Re: Tyoga Container Project
West Water Street, Painted Post, NY
Corning, (T), Steuben (C)

The following are responses to how LDG plans to address the comments from the letter you received May 14, 2020 from Kimberly Merchant of the New York State Department of Conservation (DEC) in response to Lead Agency Request Letter and Full Environmental Assessment Form (FEAF) submitted for the Tyoga Container Project (the Project) in Painted Post, New York. To help aid in review we have included DEC's comments, italicized, followed by our response to address the comments.

PROPOSED SITE PLAN

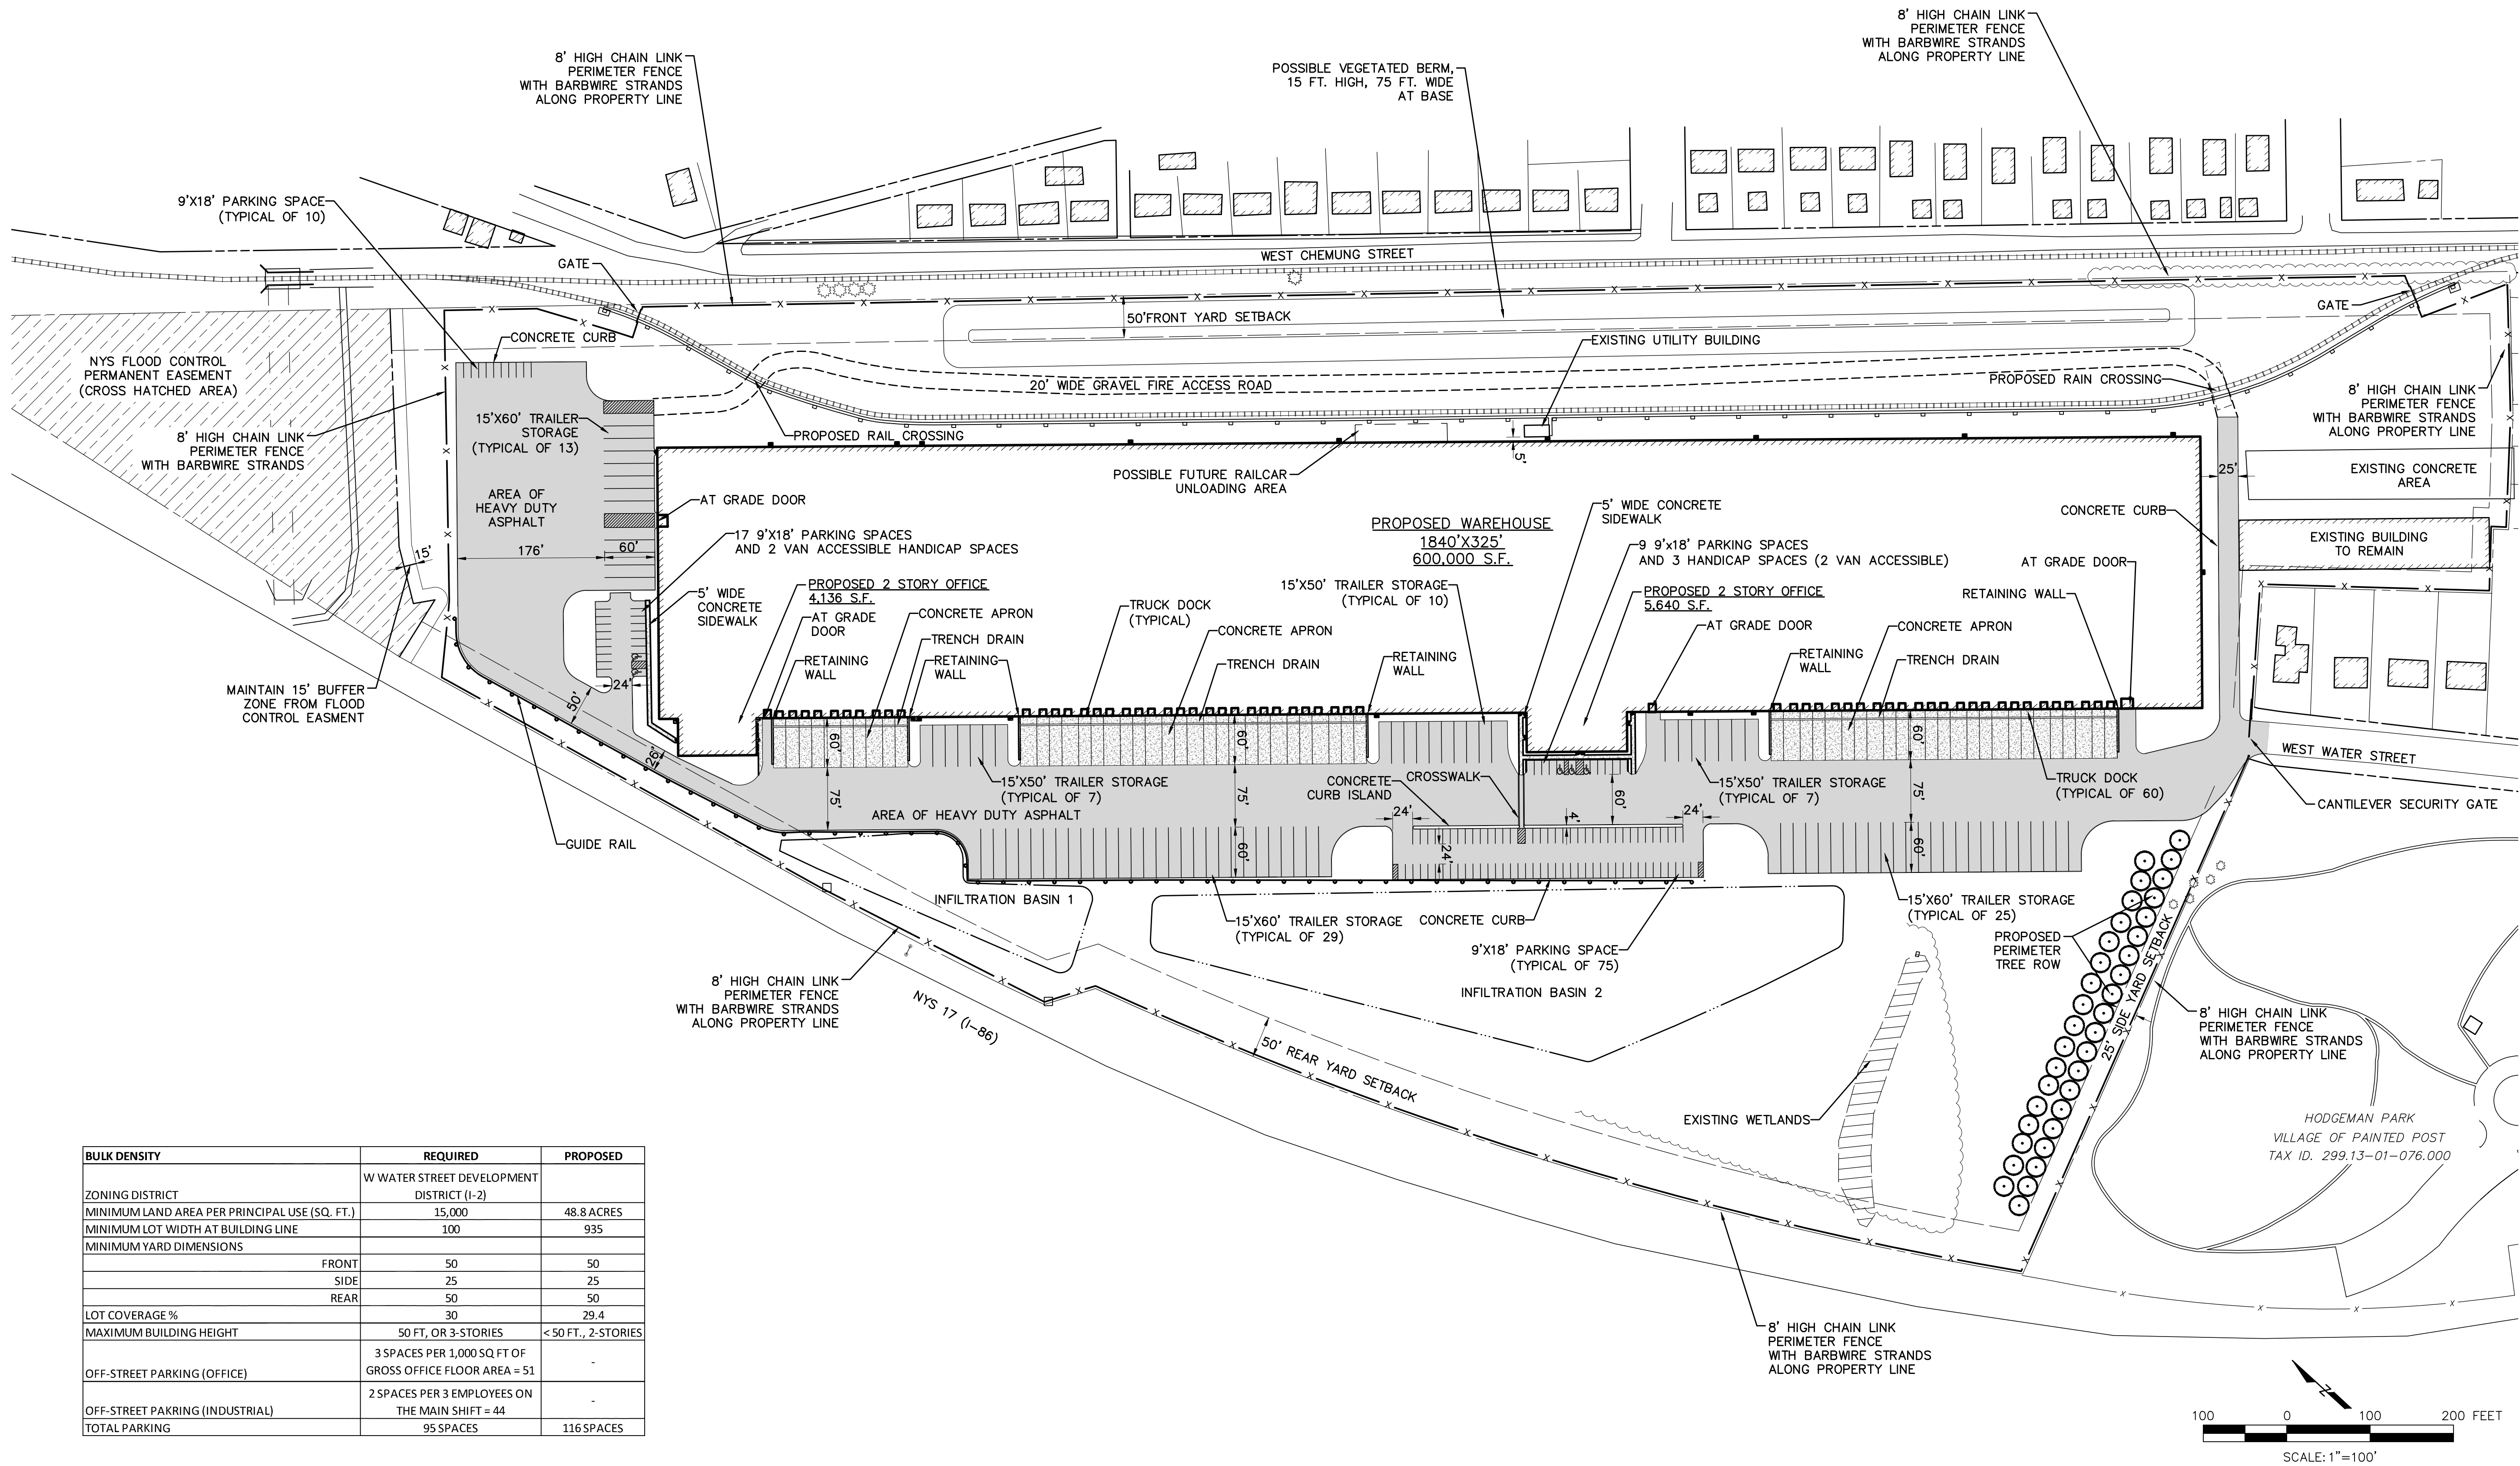
Active NYS Flood Control Perpetual Easement and Fee lands appear present on the proposed site depicted on the Preliminary Site Plan Drawing SH-1 (Site Plan). Specifically, at the western portion of the site. Submittal of a drawing for review is required that clearly depicts the location flood control lands (appropriated lands for flood control) on the site. If any regulated activities as defined in 6 NYCRR Part 501 "Use of Flood Control Lands" are proposed on flood control lands then the Department will require submittal of an Article 16 Flood Control Land Use permit application to the Department (Region 8 Division of Water – Flood Control Program) for review and comment. Examples of regulated activities on flood control lands include (but not limited to) material placement or removal, fencing, pavement, excavations, soil placement, structures, underground/overhead utilities, motorized vehicle use, stormwater, etc.

A hatched area is shown on the Site Plan over flood control lands in the area of Hodgman Creek, although a legend is not provided to identify the meaning of the hatching. Clarification is required.

A 15-foot buffer where no disturbance will occur will be maintained between the Flood Control Lands. The active NYS Flood Control Perpetual Easement and Fee lands are depicted on the attached Site Plan Drawing. No regulated activities as defined in 6 NYCRR Part 501 "Use of Flood Control Lands" are proposed on the flood control lands. Therefore, an Article 16 Flood Control Land Use permit is not required for this project.

The hatched area on the site plan has been clearly marked as Flood Control Lands. A 15-foot protective buffer region is indicated between the easement boundary and the limits of construction.
